RE: **Lot 22 Block 1 Volcano Cliffs Unit 22 SAD 228
8008 Agua Fria Ct. NW
Grading and Drainage Plan
Engineers Stamp Date 10/21/2020 (D10D003N22)
Pad Certification Dated: 5/10/2021**

Based upon the information provided in your submittal received 6/25/2021, this plan is approved for Building Permit.

**Re: Pulte at Volcano Cliffs Unit 18
Erosion and Sediment Control Plan
Engineer's Stamp Date 6/17/2021 (D10E003_P)**

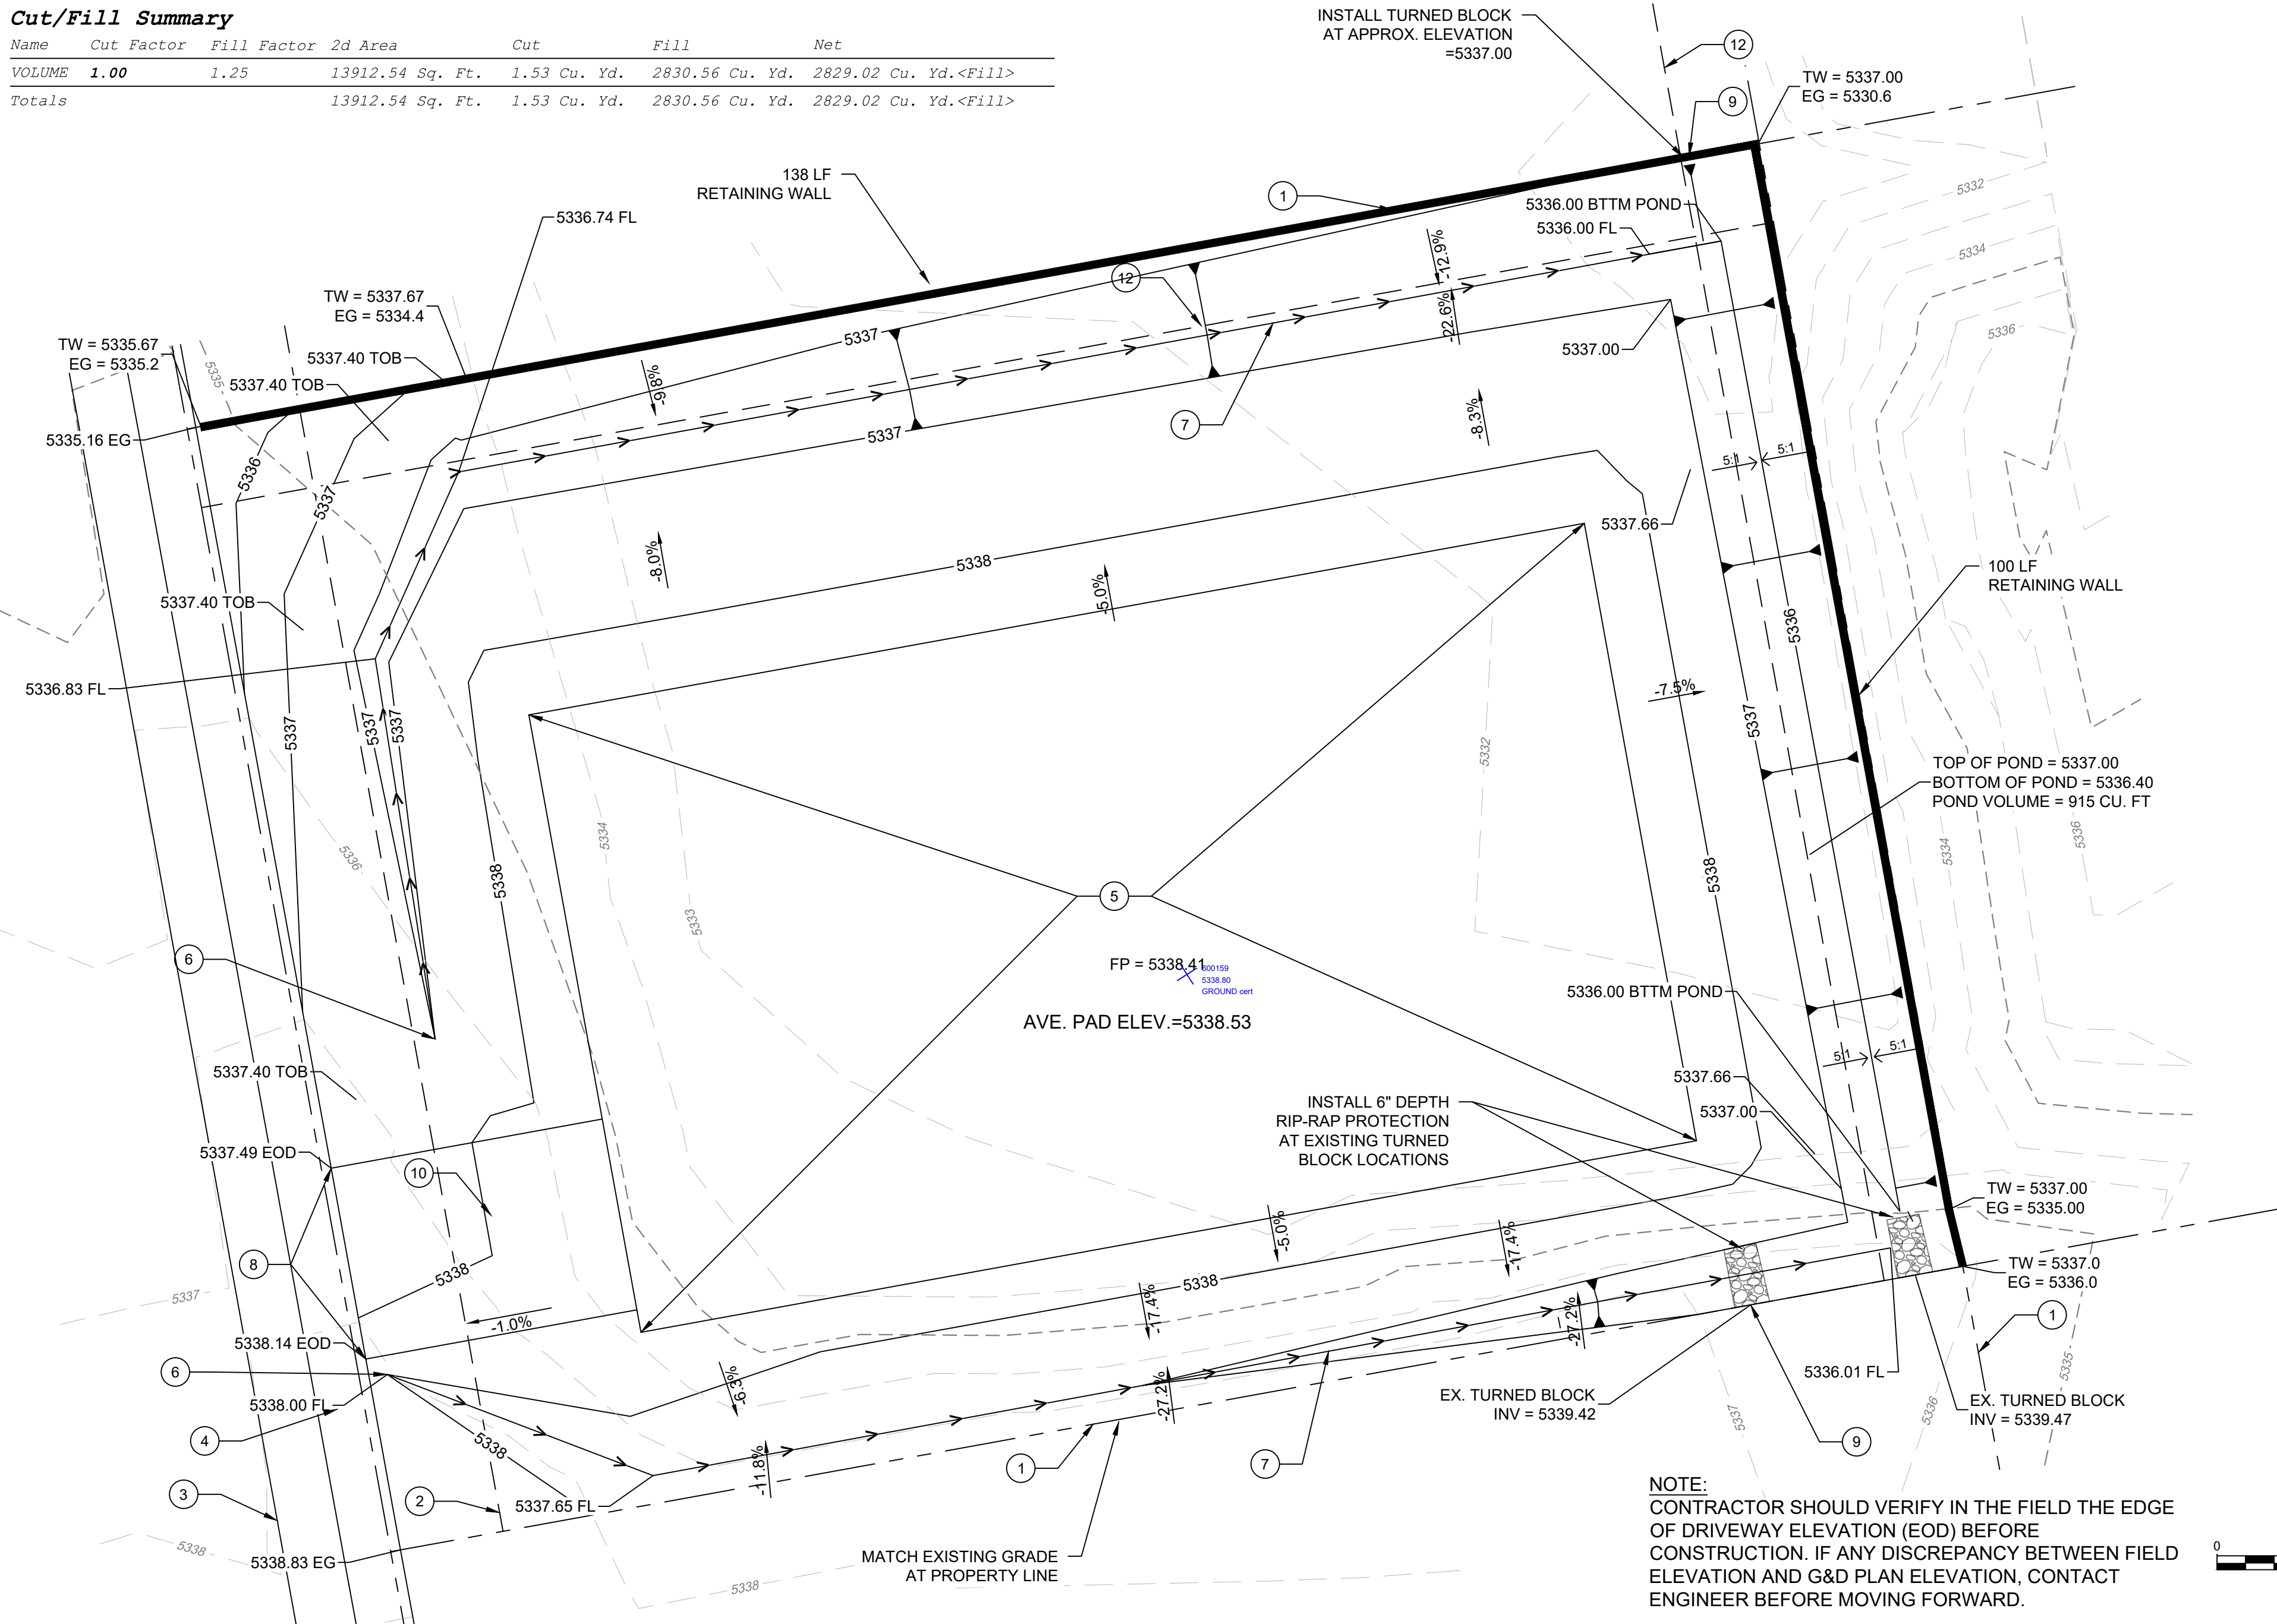
Reiterate to the Owner/Contractor that a separate permit for a garden/retaining wall must be obtained with the approved G&D plan and Pad Certification. **Also, if a swimming pool is to be placed the grading and drainage plan will change and will need to be resubmitted showing location of pool and land treatment changes.**

Prior to Certificate of Occupancy release, Engineer Certification per the DPM checklist will be required.
